Texas A&M University Quiet Zone College Station, Texas

Public Authority Application

Public Authority Application - Project Summary

April 13, 2021

DOT No. 743215B

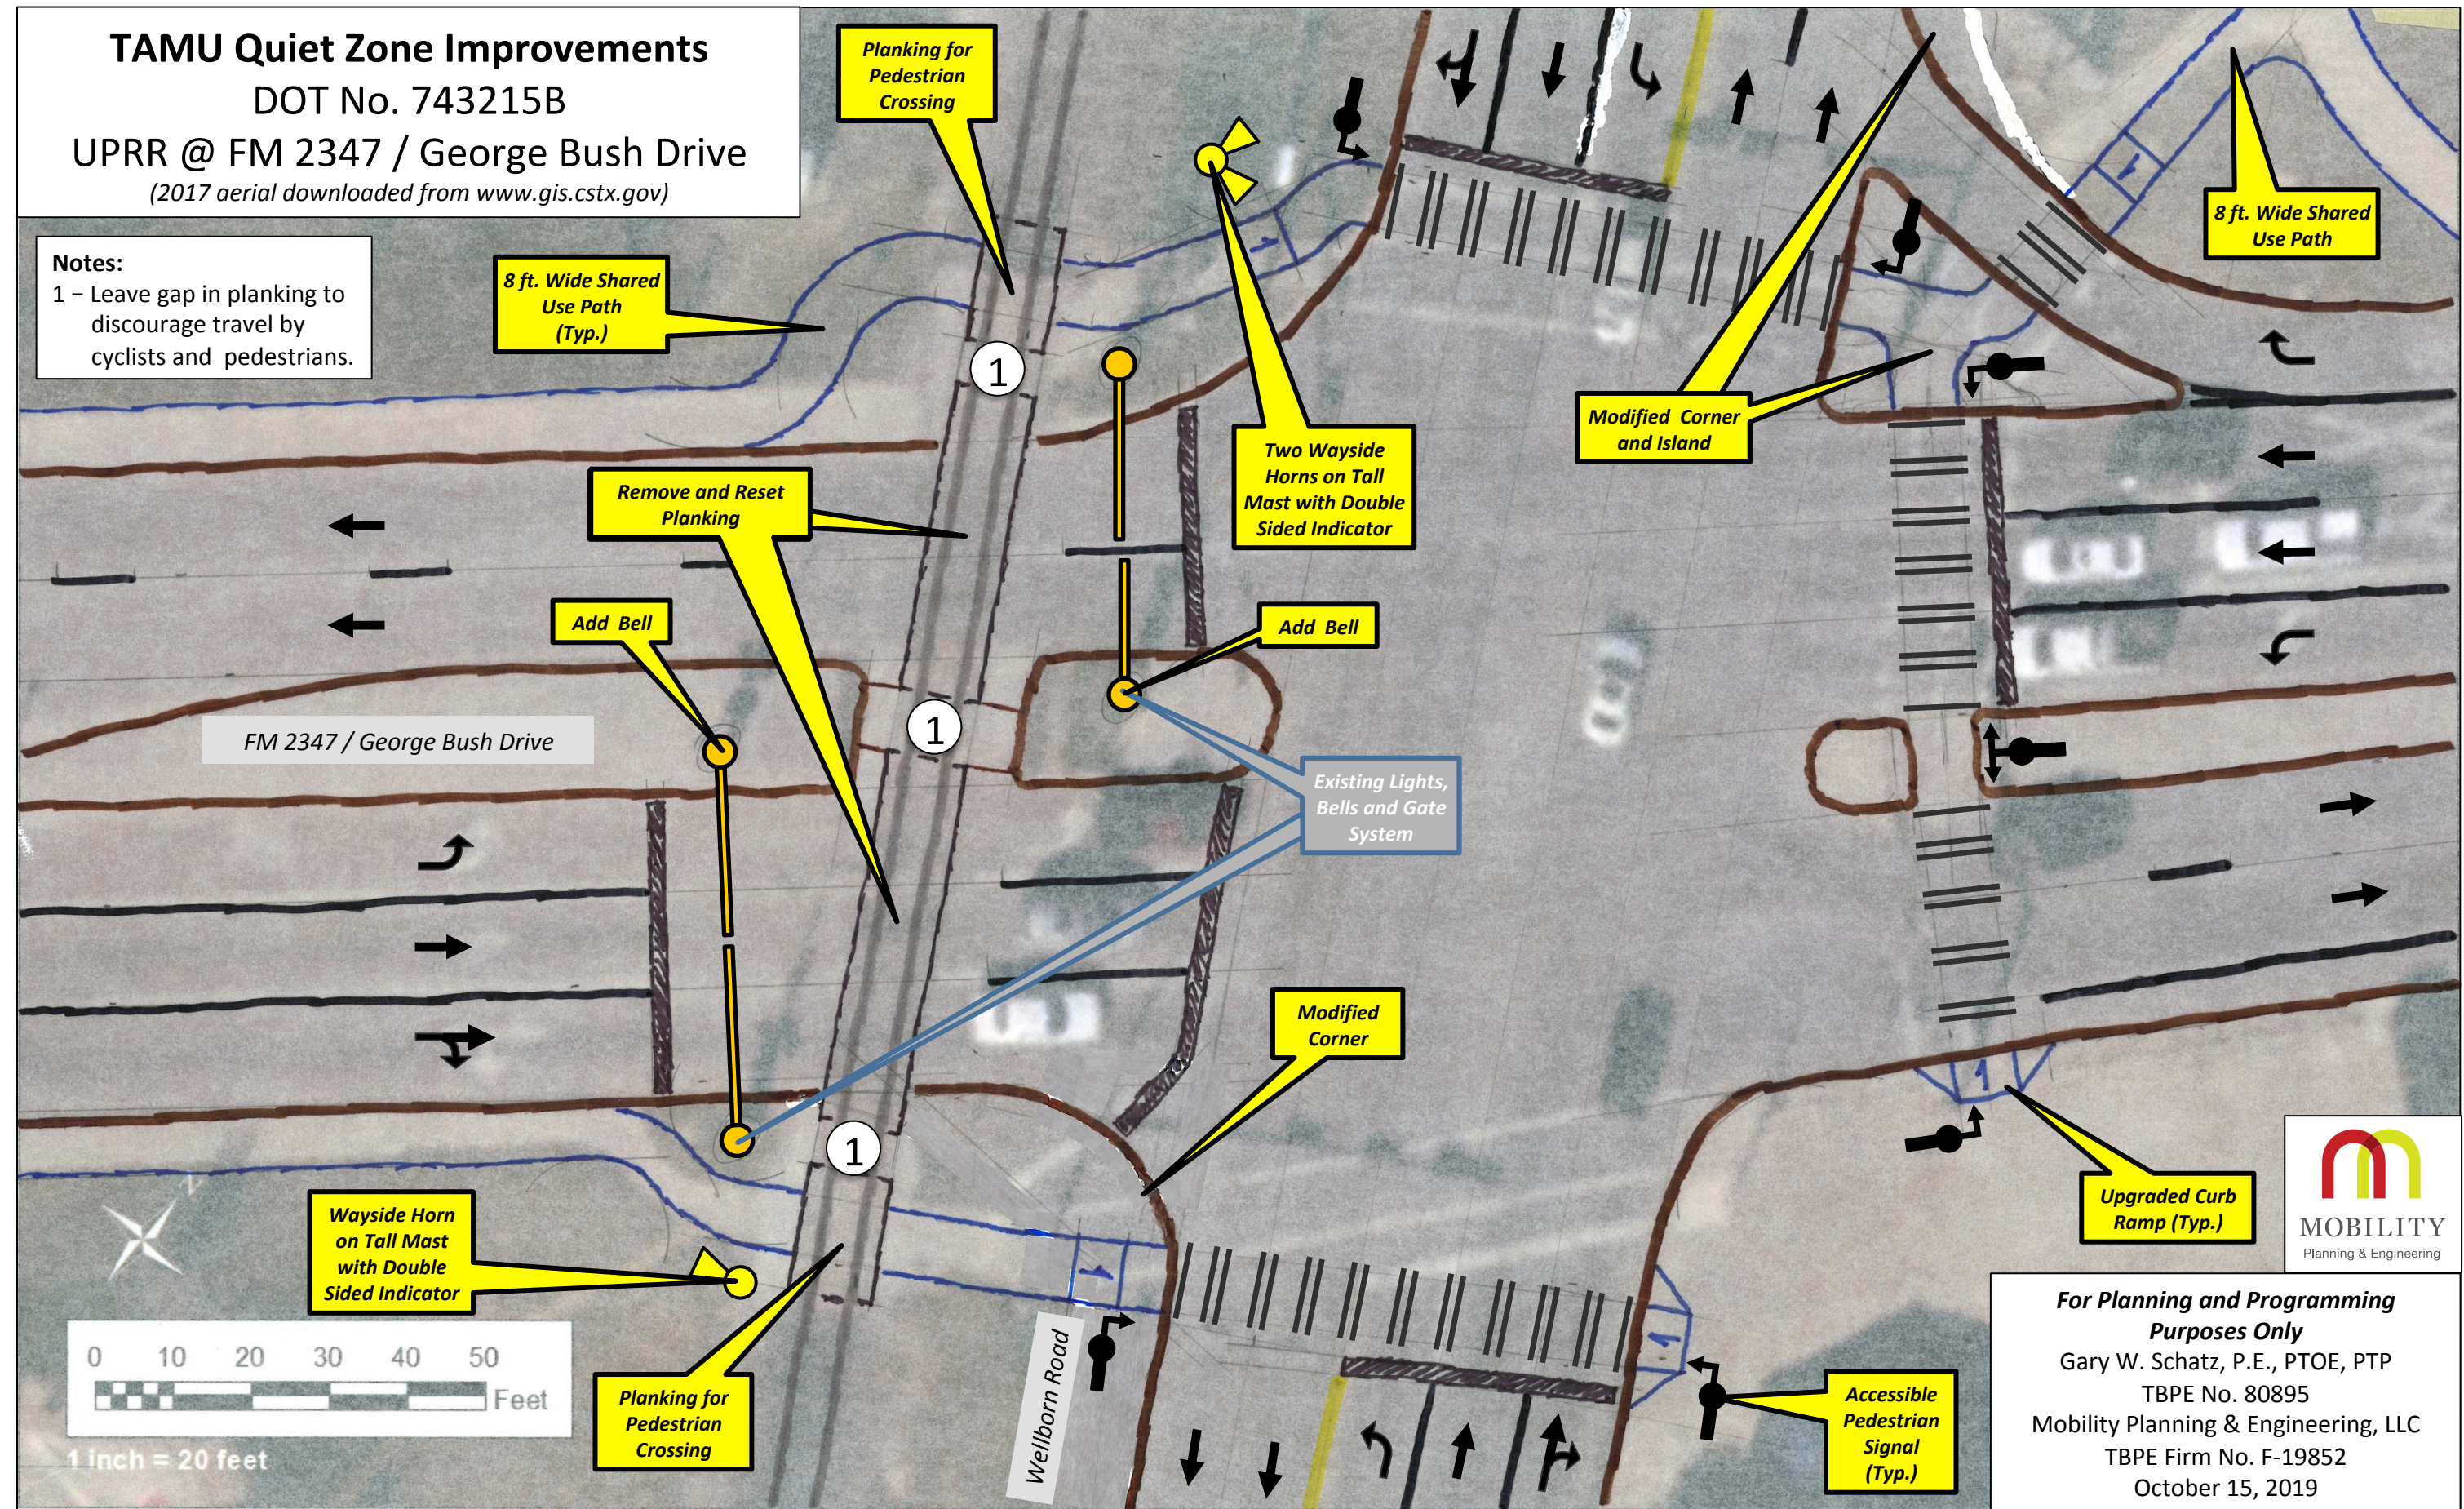
UP acknowledges the Public Authority's plan to install a wayside horn system to provide warning on each approach to the crossing. Track curvature and vegetation along the train approaches must be addressed during the wayside horn design phase. Current pedestrian and cyclist treatments will be modified and enhanced to encourage safe and proper use of the crossing. Once the final plans are prepared for the safety treatments at this crossing, UP requests a copy and reserves the right to comment further.

TAMU Quiet Zone Improvements
 DOT No. 743212F
 UPRR @ John Kimbrough Boulevard
 (2017 aerial downloaded from www.gis.cstx.gov)

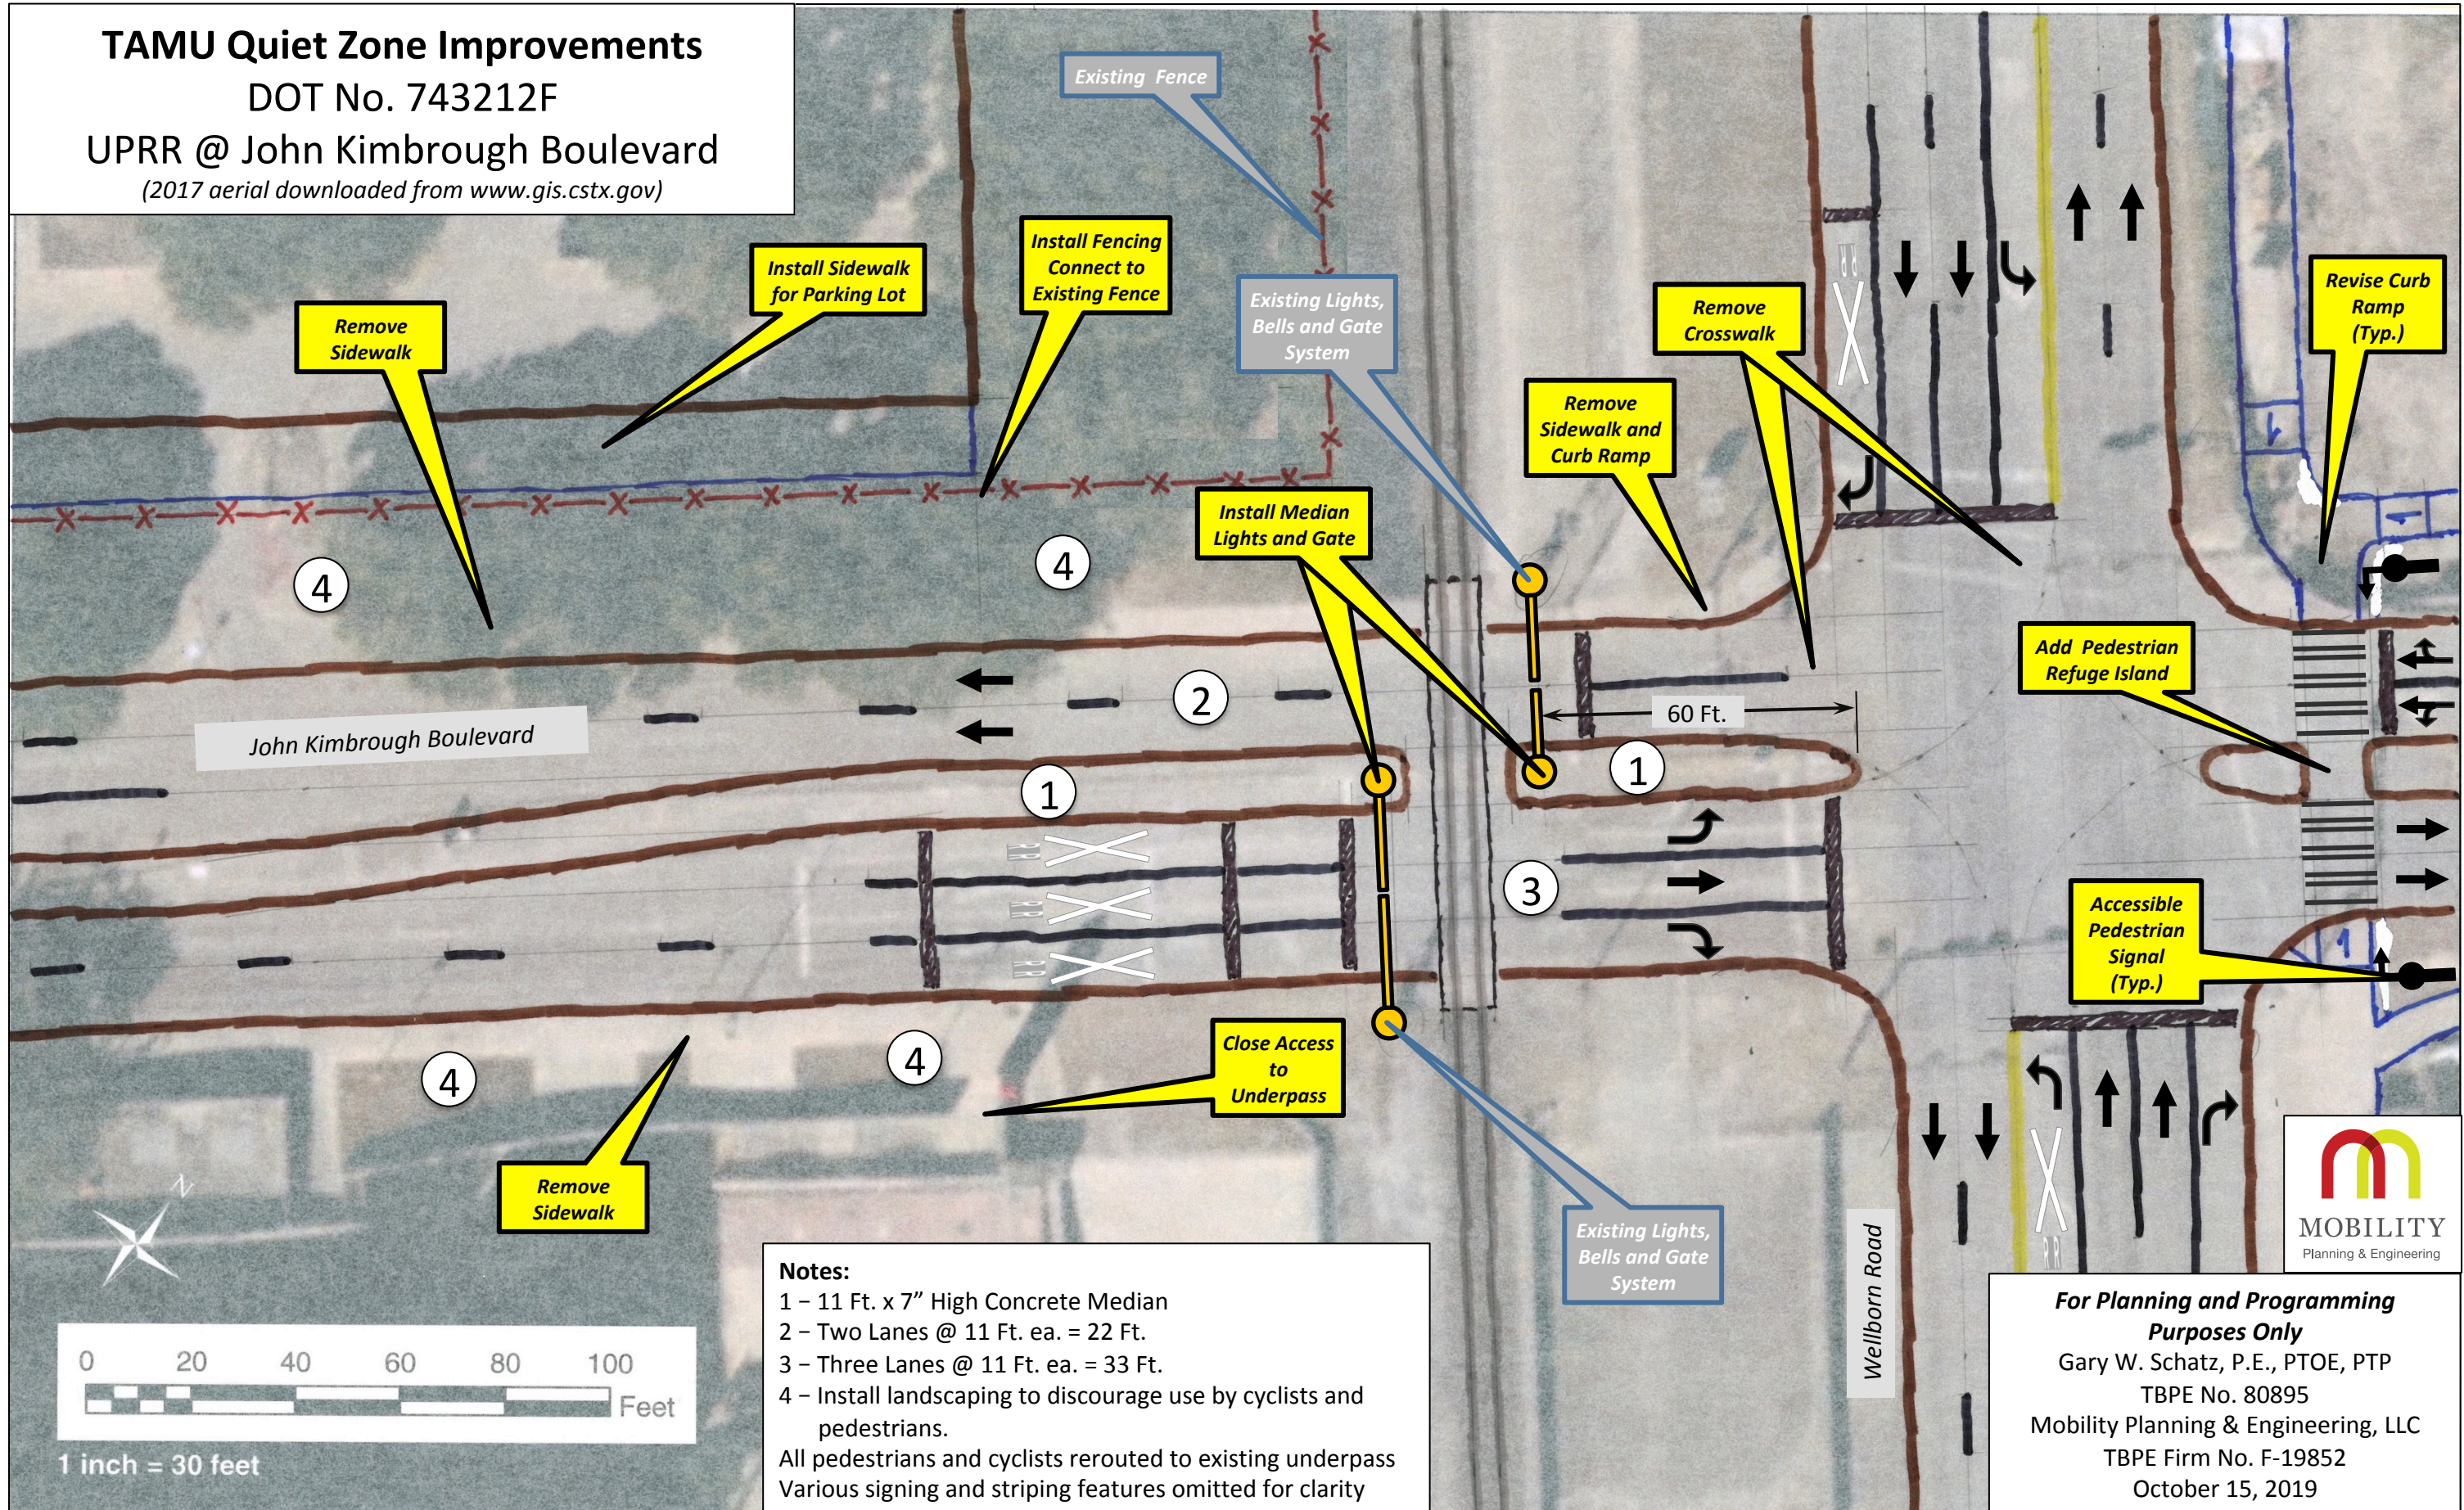
UP acknowledges the Public Authority's plans to implement non-traversable concrete medians as SSMS at this crossing. The NOI plans indicate the median on the westbound approach will be 60 feet in length and the existing median on the eastbound approach exceeds 100 feet in length. Median gates are also planned for both approaches.

The Public Authority plans to eliminate or modify all current pedestrian approaches and treatments to the crossing. Fencing along the edge of the adjacent parking lot in the northwest quadrant and landscaping is planned to discourage pedestrians and cyclists from travel along the sidewalk approaches that are removed. Pedestrians and cyclists will be re-routed to the existing underpass on the south side of the crossing. Once the final plans are prepared for the safety treatments at this crossing, UP requests a copy and reserves the right to comment further.
